SOUTHERN REGIONAL PLANNING PANEL – ADDENDUM REPORT

RPP No.	PPSSTH-103
DA Number	DA-2021/1071
Local Government Area	Southern Regional Panel - Wollongong
Proposed Development	Cliff stabilisation coastal protection works
Street Address	1 Craig Street, Thirroul
Applicant/Owner	Jarrold Etherington
Lodgement date	21 September 2021
Recommendation	Approval
Number of Submissions	None
Regional Development Criteria (Schedule 7 of the SEPP (State and Regional Development) 2011	Coastal Protection Works
List of All Relevant s 4.15(1)(a) Matters	<p><u>s4.15 (1)(a)(i) Any environmental planning instruments:</u></p> <p><i>Acts</i></p> <ul style="list-style-type: none"> Coastal Management Act 2016 No. 20 The Coastal Management Amendment Act 2021 <p><i>State Environmental Planning Policies (SEPPs)</i></p> <ul style="list-style-type: none"> State Environmental Planning Policy No. 55 – Remediation of Land State Environmental Planning Policy (Infrastructure) 2007 State Environmental Planning Policy (State and Regional Development) 2011 State Environmental Planning Policy – (Resilience and Hazards) 2021 <p><i>Local Environmental Planning Policies</i></p> <ul style="list-style-type: none"> Wollongong Loc

Title:
**Shotcrete Retaining Wall Concept Plan
1 Craig St, Thirroul**

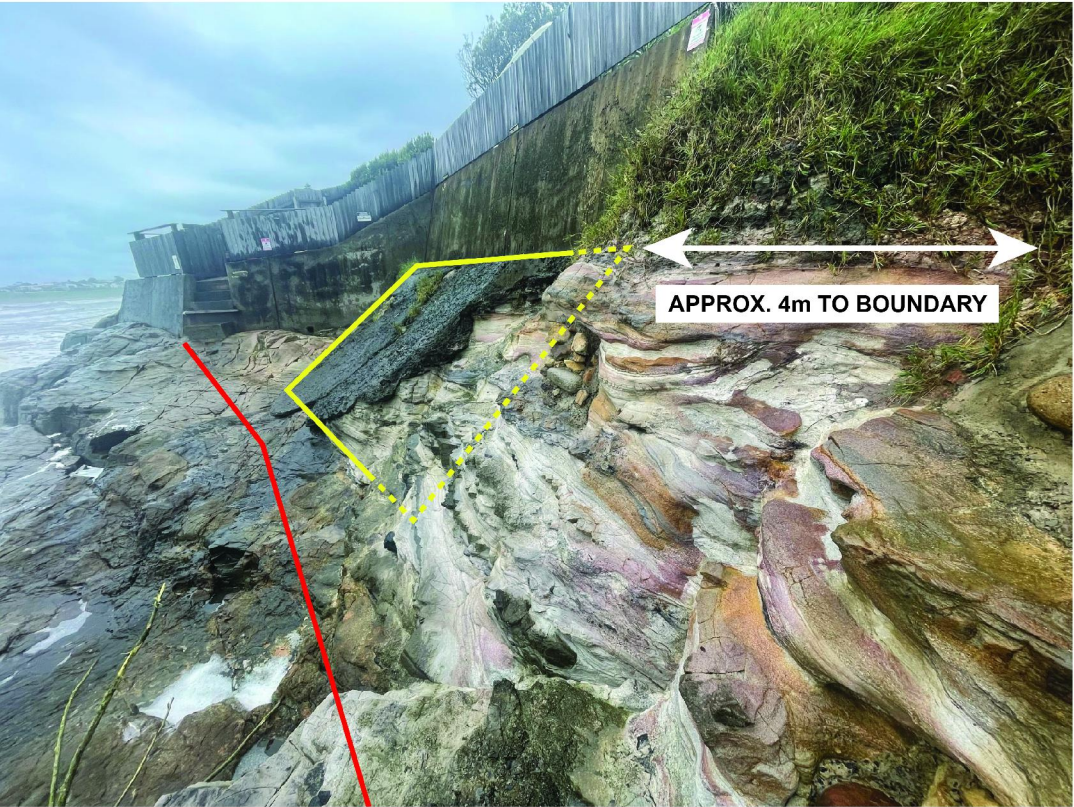
- An illustration in plan view of the location and extent of all proposed works. Ideally, this could be overlain on the detailed survey plan provided in the Council Assessment Report. This illustration should clearly identify the extent of shotcrete to be placed, particularly over existing cliff and boulders on the foreshore.

- An illustration in elevation view of the extent of all proposed works along the eastern (seaward) boundary of the site. Ideally, this would be as a photo montage clearly showing all stabilisation elements to be placed on the existing cliff and rock face, the extent of the shotcreting and any other concrete elements along width of the eastern boundary; and any works at or around the existing stormwater outlet at the north-eastern corner of the Lot.

Despite this, an indicative extent has been provided in the plan view of the works developed in parallel with this response. Note that this extends through to the area where the cliff slumping transitions to a more stable area, as shown in the photo below taken from Horton (2020). This area is set back approximately 4 m from the northern property boundary of 1 Craig Street.

This letter is accompanied by updated plan and elevation views of the works, as requested by the panel. Note that these plans provide more detail of the works but no actual change to the works applied for is proposed as part of this response. These plans are not detailed but show the extent of works. More detailed plans are not possible at present due to the need for the works to reflect actual conditions at the time (see further below).

As can be seen from Figure 1.1, much of the shoreline of the property is already a highly reflective environment. While shotcreting works will lead to an increased 'smoothing' of this area compared to present, this is not anticipated to materially change the wave climate for the area. Importantly, as the area already has a high level of wave reflection, the shotcreting will not represent a fundamental change in shoreline type which may otherwise lead to more significant changes in wave activity. Additionally, the shotcreting works are not proposed to cover the entire cliff face and foreshore, and therefore will preserve some of the existing 'complexity' of the environment that assists in slowing wave movement. This can also be seen in review of the works undertaken at the adjoining (southern) Council road reserve where shotcreting and rock-bolting have also been undertaken, without major changes in wave climate.

Without a material change in wave reflection, the works are not anticipated to cause a major change to coastal hazards in the area. The main driver for cliff instability is preferential erosion within the siltstone band of the cliff face, following exposure of sand levels. Sand exposure itself is driven primarily as a result of storm erosion, rather than ongoing (wave-driven) longshore processes). Any change in wave reflection at the cliffs, therefore, is not expected to drive sand scour and subsequent cliff instability of adjoining areas. Note also that as the 'end' of the works will be set back several metres from the
